Plan Name: LOT LINE CHANGE PLAN FOR KLEINFELTER / LIBERTORE, 955 & 1015 TRAIL ROAD NORTH			
Plan No.: 24-011	Plan Date: May 3, 2024		
Location: 955 & 1015 TRAIL ROAD NORTH, ELIZABETHTOWN, PA 17022			
Property Owner: MARK KLEINFELTER- LOTS 1 & 4, FRANK LIBERTORE-LOT 3			
Owner Address: 955 & 1015 TRAIL ROAD NORTH, ELIZABETHTOWN, PA 17022			
Telephone No.: 717-449-0268			
E-mail: kleinfelterm@comcast.net			
Deed Reference: 6736-412, 6146-091		Tax Parcel No.: 2304339-318017, 2304572-318948, 2303693-317878	
Plan Type:	<input type="checkbox"/> Sketch	<input type="checkbox"/> Preliminary	<input type="checkbox"/> Final
	<input checked="" type="checkbox"/> Lot Line Change	<input type="checkbox"/> Minor Agricultural or Land Development	
Description: The purpose of this plan is to subdivide Interim Lot 4A and Lot 4B from Existing Lot 4. Interim Lot 4A and Lot 4B is to be added to Existing Lot #1 and Lot #3 to create proposed Lot #1 and Lot #3, respectively, and be unified by deed.

Re: Waiver request for Lot Line Change
 Plan for Kleinfelter / Libertore
 955 & 1015 Trail Road North
 AOA# 24-011

Re: Lot Line Change Plan for Kleinfelter/Libertore
Township Permit No. 24-11-LLCP
LCEC Project No

OVERALL EXISTING BOUNDARY CONFIGURATION

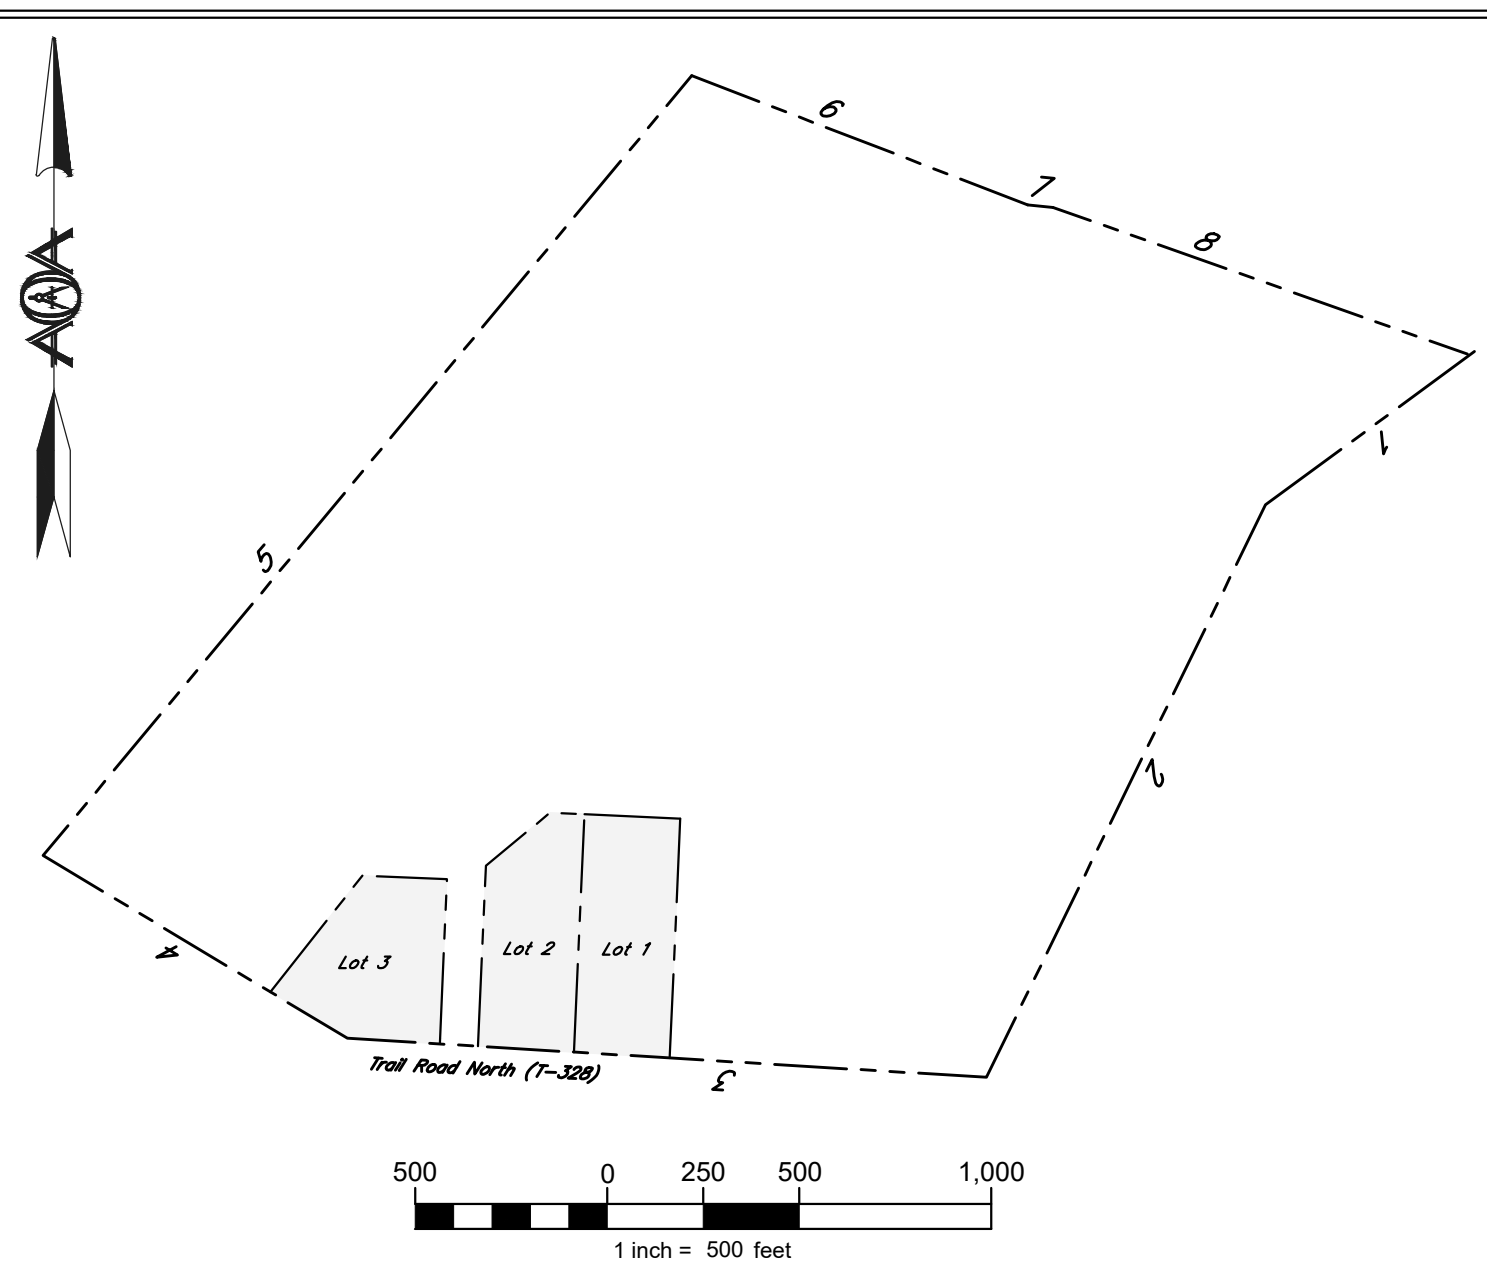
Due to the size of Lot 4 (114.22 acres) on this plan, the plan scale on sheet 2 is 150 feet to the inch. The remaining plan scales on sheets 3 & 4 comply with Township regulations.

9. The existing conditions plan shall be shown at a scale between 20 feet and 100 feet to the inch (119-31.A(1)). The applicant has requested a modification of this requirement.

Modification response: The existing plans sheet is shown at a scale of 150 feet to the inch in order to show all of Lot 4 (114.22 acres). The proposed lot line changes are shown at a scale of 80 feet and 100 feet to the inch. Based on these considerations, I have no objections to a modification of this requirement.

EXISTING CONDITIONS

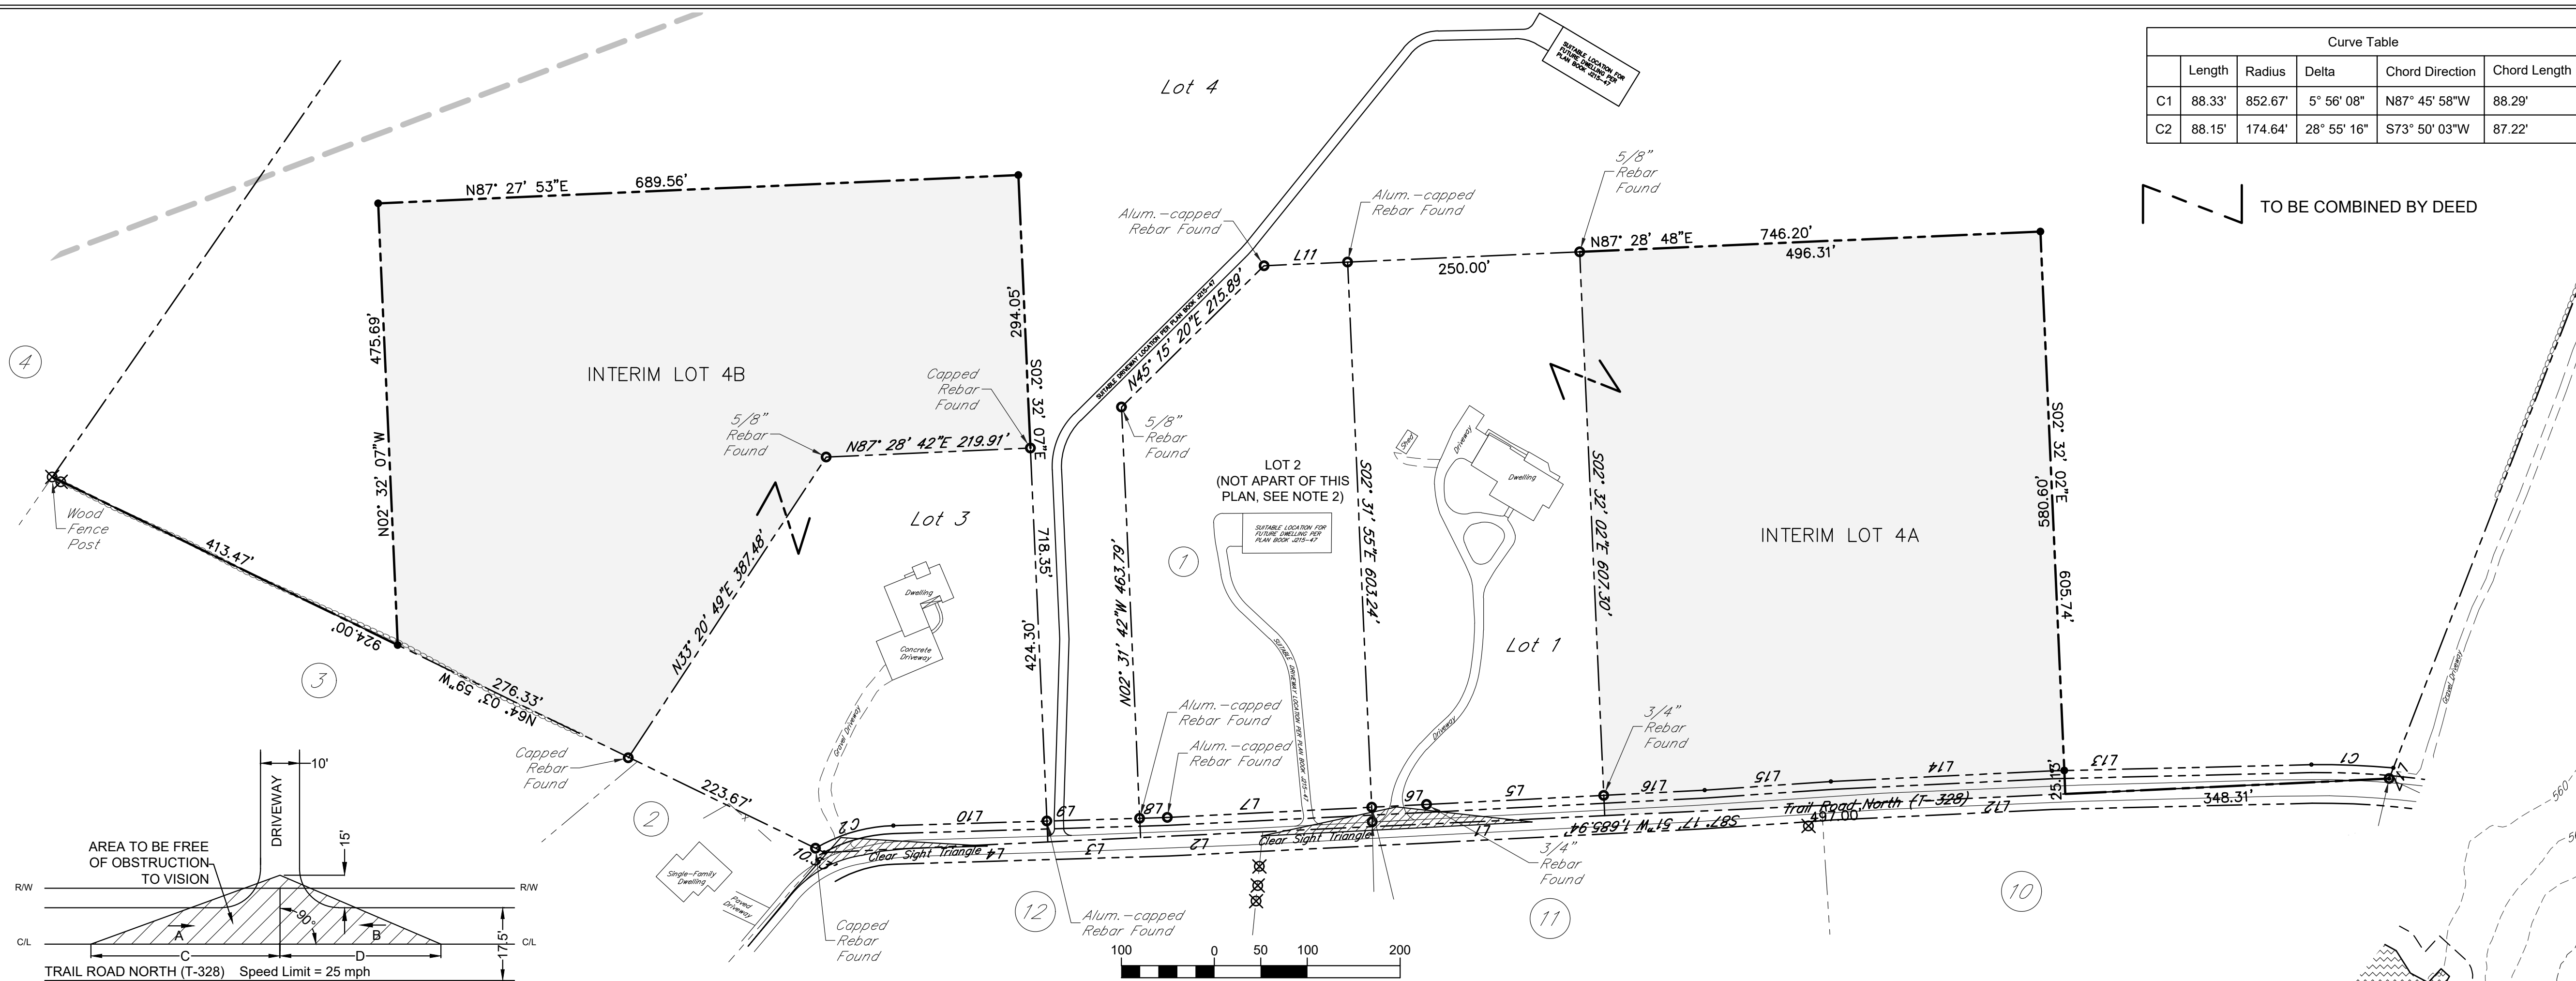
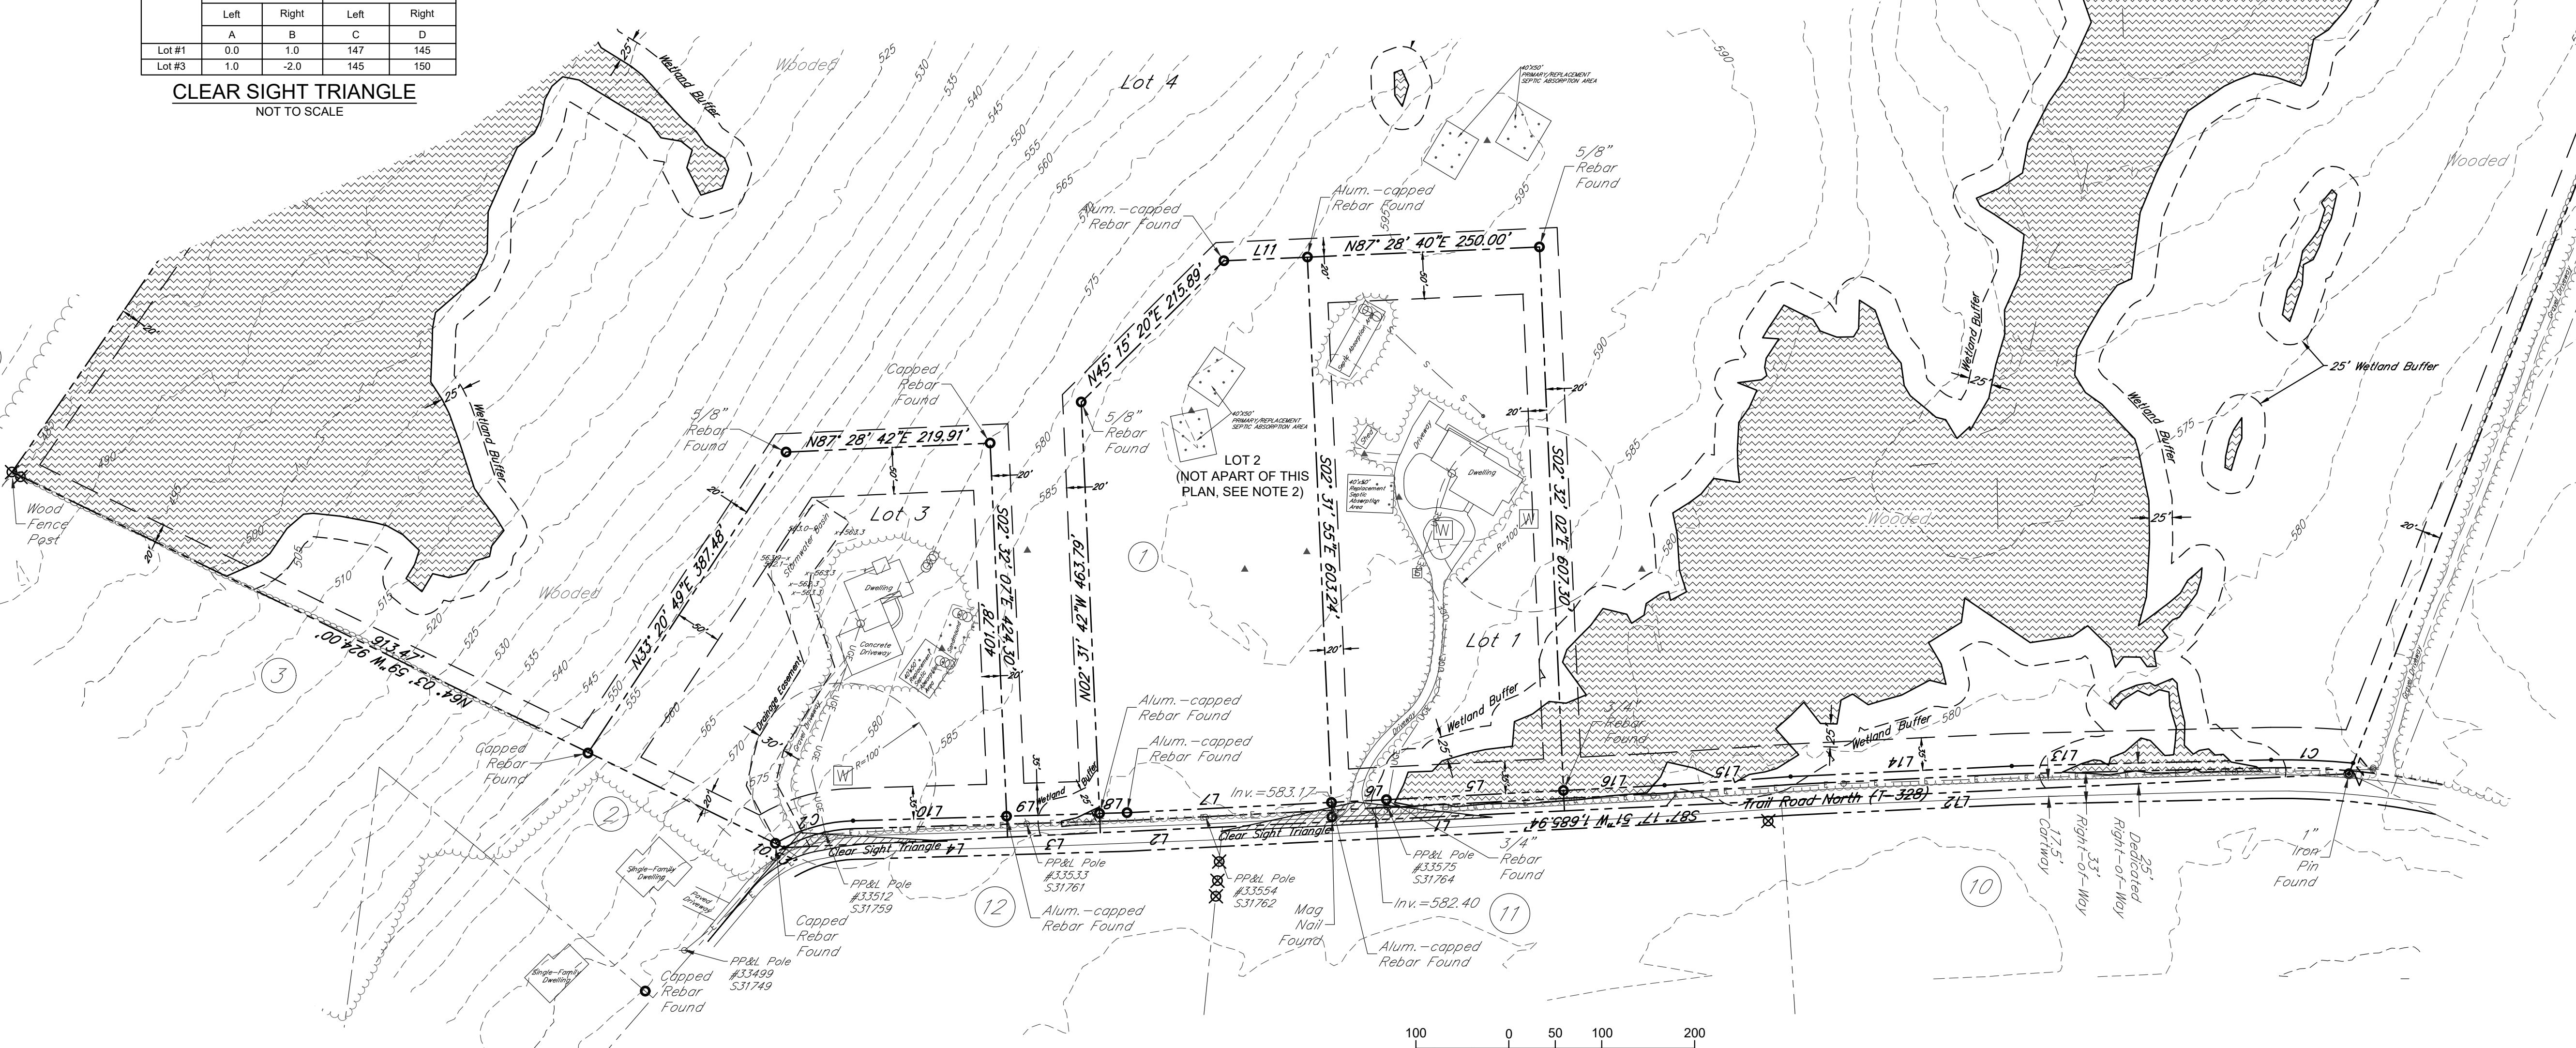
25. Note 9 states that no structures, landscaping or grading may be constructed, installed or performed within the area of the clear sight triangle which would obscure the vision of motorists; however existing landscaping/vegetation is shown within the clear sight triangles for Lots 1 and 3. Deeds to lots which contain clear sight triangles shall provide the restrictions in Note 9 on the Cover Sheet (119-52.L). The applicant shall confirm that the clear sight triangles for Lots 1 and 3 shown on Sheet 3 of the plans are consistent with Note 9.
